Addendum No. 4

RE: Contract # C204499

Guilford County (R-4707)

INTERCHANGE OF US-29 AND SR-4771 (REEDY FORK PARKWAY)

PROJECT REFERENCE NO. R-4707	SHEET NO. W-3
GEOTECHNICAL ENGINEER  J. Shane Johnson 773ECAA5F84423	
DOCUMENT NOT CONSIDERED FINAL UNLESS ALL SIGNATURES COMPLETED

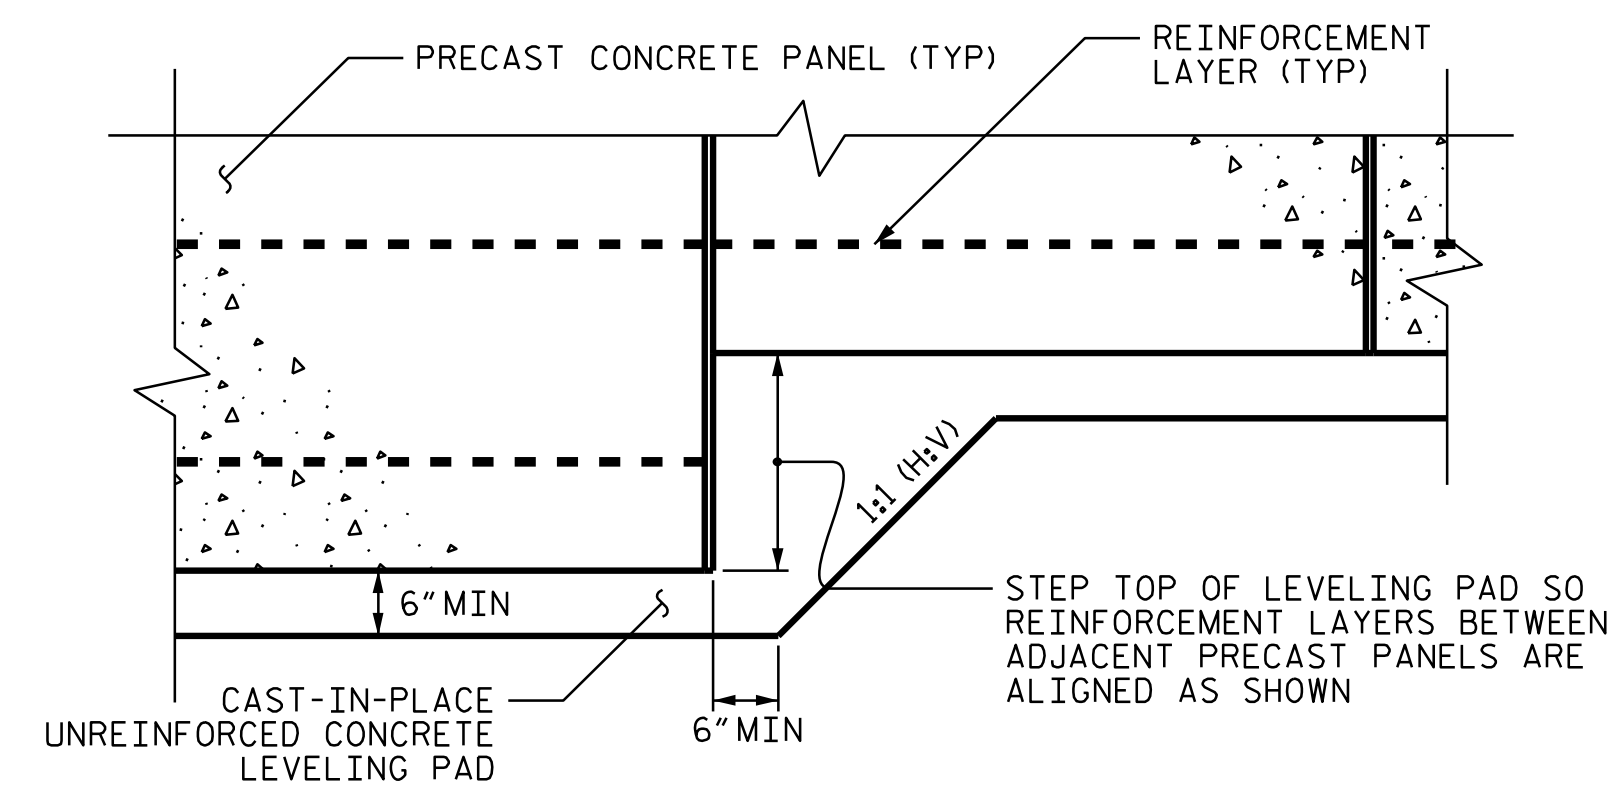
Sheet No.	Revision
W-3	Notes 8, 9, 10, and 11 were revised to match the pile driving sequence in the Bridge plans

7. A DRAIN IS REQUIRED FOR RETAINING WALLS AT END BENTS NO.1 AND NO.2.
8. DRIVE PILES AT END BENT NO.1 AND END BENT NO.2 PRIOR TO BEGINNING MSE WALL CONSTRUCTION.

9. INSTALLATION OF 24-INCH DIAMETER CORRUGATED METAL CANS OR YELLOW JACKET™ PILE SLEEVES AROUND THE PILES AFTER THEY ARE DRIVEN FROM THE BOTTOM OF THE PILE CAP TO THE LEVELING PAD ELEVATION IS REQUIRED FOR PILES AT END BENT NO.1 AND END BENT NO. 2 .

10. THE CORRUGATED METAL CANS SHALL BE DESIGNED TO WITHSTAND THE PRESSURES FROM COMPACTION OPERATIONS ON ADJACENT FILL WITHOUT DISTORTION. AT A MINIMUM, CORRUGATED METAL CANS SHALL BE 16-GUAGE WITH A WALL THICKNESS OF 0.064 INCHES.

11. LOOSELY BACKFILL CORRUGATED METAL CANS USING THE SAME MATERIAL AS MSE REINFORCED ZONE PRIOR TO CONSTRUCTION OF THE END BENT PILE CAP. DO NOT COMPACT MATERIAL WITHIN THE CAN.
